# Intel<sup>®</sup> 80219 General Purpose PCI Processor

Specification Update

*July 2004*

Document Number: [274020-002](#)

**Figure 2. Intel® 80219 General Purpose PCI Processor P\_BMI Signal Implementation for Intel® 80219 General Purpose PCI Processor B-0/B-1 Stepping**

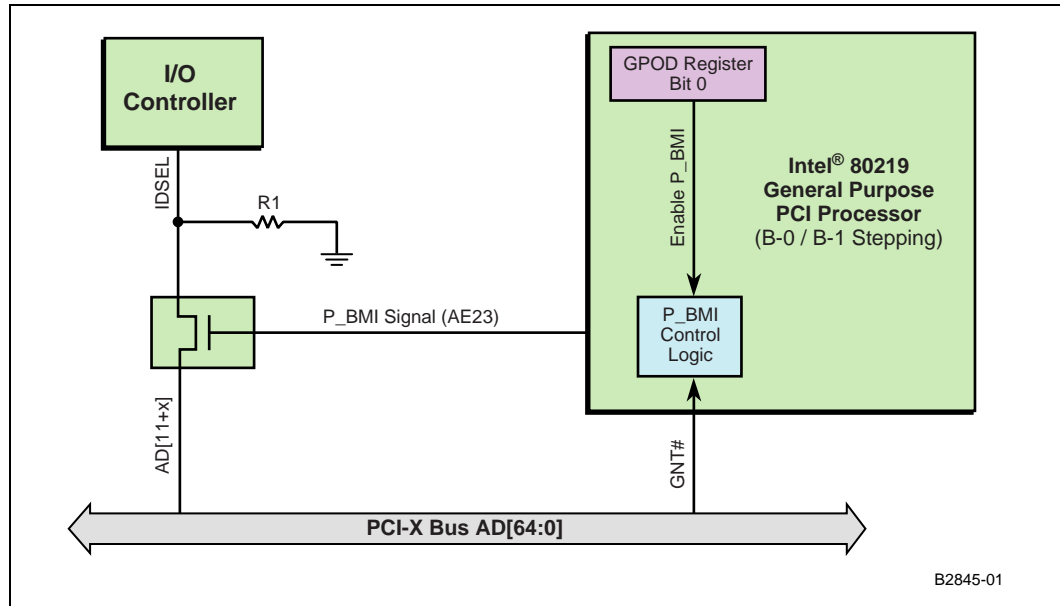
## 1. Signal NC2 was renamed to P\_BMI (AE23). New function added to signal P\_BMI.

The P\_BMI (AE23) signal has been added to the Intel® 80219 general purpose PCI processor. This signal replaces, using an external GPIO pin for Initialization Device Select (IDSEL) control of an I/O device during host configuration cycles.

The 80219 has eight integrated General Purpose Input Output (GPIO) pins, referred to as GPIO[7:0]. These pins, along with the new PCI-X Bus Master Indicator (P\_BMI) signal, can be used to control the IDSEL to the I/O device. External circuitry is no longer required other than a simple switch. The output function of the P\_BMI signal is controlled by the GPIO Output Data Register (GPOD), Bit 0 as shown in Table 1. The P\_BMI signal is always driven and defaults to driving low at power up.

The IDSEL signal is used as a chip select during configuration cycles initiated by the BIOS, operating system or 80219. The GPOD[0] can be driven low in firmware, thereby disabling the P\_BMI signal and hiding the host I/O device from the system, by turning off its IDSEL. When the 80219 intends to perform configuration cycles in the PCI bus segment of the I/O device, the P\_BMI signal should be asserted high by driving the GPOD[0] high. The affect of these two operations is, that the I/O device is initialized and controlled by the 80219. More care must be taken with the gate chosen to control IDSEL, since most host bridge controllers do not use PCI address stepping. With IDSEL being a synchronous signal, with respect to CLK, the switch used must be a sub nanosecond propagation delay device (e.g., Pericom PI5C3303). In Figure 2, the P\_BMI signal is used to control a MUX/DeMUX switch that is used to enable/disable IDSEL to the I/O device.
